File Number: 7-B-25-IH

Location: 3300 Orlando St. **Parcel ID:** 69 L E 020
Zoning: RN-2 (Single-Family Residential Neighborhood)
Description:
New primary structure.

Level III New Primary Structure

Revised design for new primary residence fronting Orlando Street. The initial submission was approved with conditions by the Design Review Board in 2021 (12-A-21-IH), and the elevation drawings were later revised and approved by the Board in 2022 (5-A-22-IH). The revised proposal makes significant modifications to the previously approved site plan and elevations.

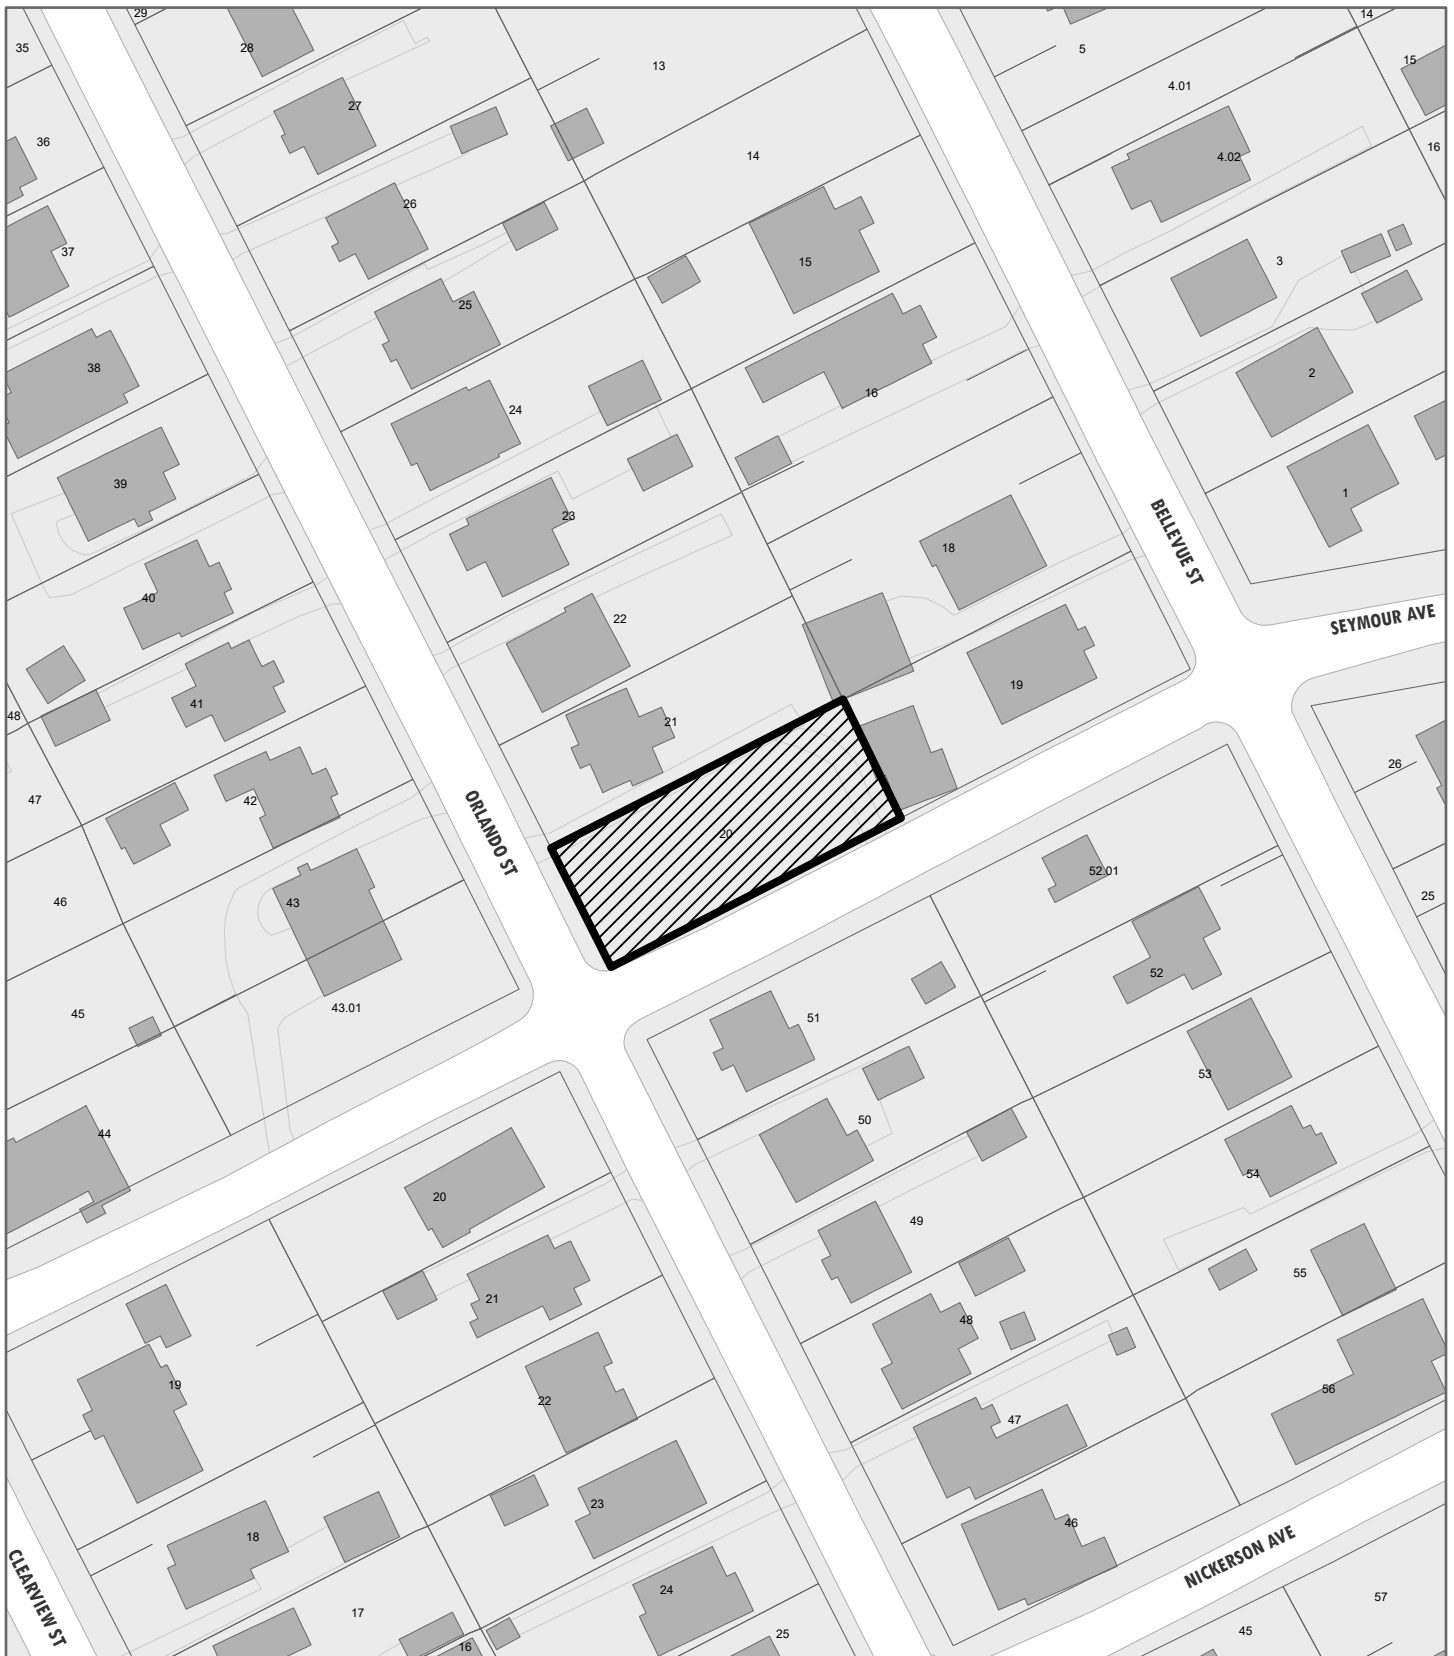
5. The plans that were previously approved by the Board were two-story with a 7/12 front-gable roof and raised

foundation to match the historic context. However, the revised plans feature a 10/12 pitch front-gable roof, which will likely increase the height and visual scale of the house. The three two-story houses on the block all feature side-gable roofs, two of which are low-pitch and one with a steeply pitched roof characteristic of its English Cottage Revival style. The Board extensively discussed and ultimately approved the two-story height compared to the context in 2021 and 2022.

5. The design features a half-length, 8'-6" deep front porch recessed under a shed roof and supported by two square posts, which meets the design guidelines. The porch supports should be at least 8" by 8" to match the context.

6. Guidelines recommend window and door styles be similar to historic houses on the block with a similar ratio of solid to void. All elevations feature significant transparency. The 4/4 single-hung windows and half-lite paneled door match the context, and the design benefits from the paired and grouped window arrangements.

7. The asphalt shingles and vinyl siding meet the design guidelines for materials. The slab foundation should be parge-coated or clad in stucco. The proposed chimney should be clad in either brick or stone veneer, as indicated.

Staff recommends approval of Certificate 7-B-25-IH, subject to the following conditions: 1) final site plan to meet City Engineering standards; 2) final site plan to include a tree in the rear yard and the existing magnolia tree to be retained and protected during construction; 3) the porch supports to be at least 8" by 8"; and 4) the foundation to be parge-coated or clad in stucco.
